W50S9C-23-B-0001
Expand Photovoltaic (PV) Array
QUESTIONS and ANSWERS

As of 8/16/23

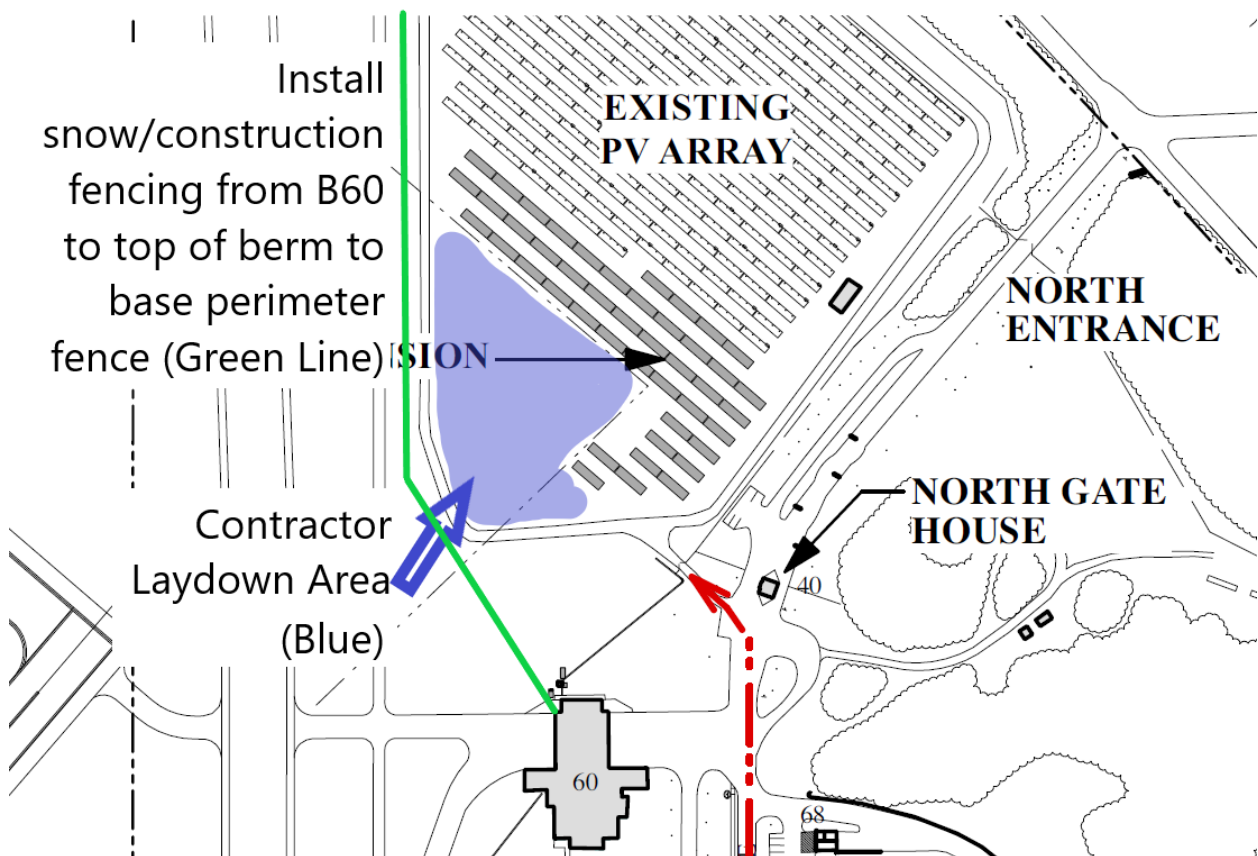
2. Question: Where is the laydown area?

Answer: The laydown area is depicted below. Contractor to install construction snow fencing from fire department to connect to the installation perimeter fence line. See picture below. Contractor is responsible for returning the laydown site to existing conditions upon conclusion of the project.
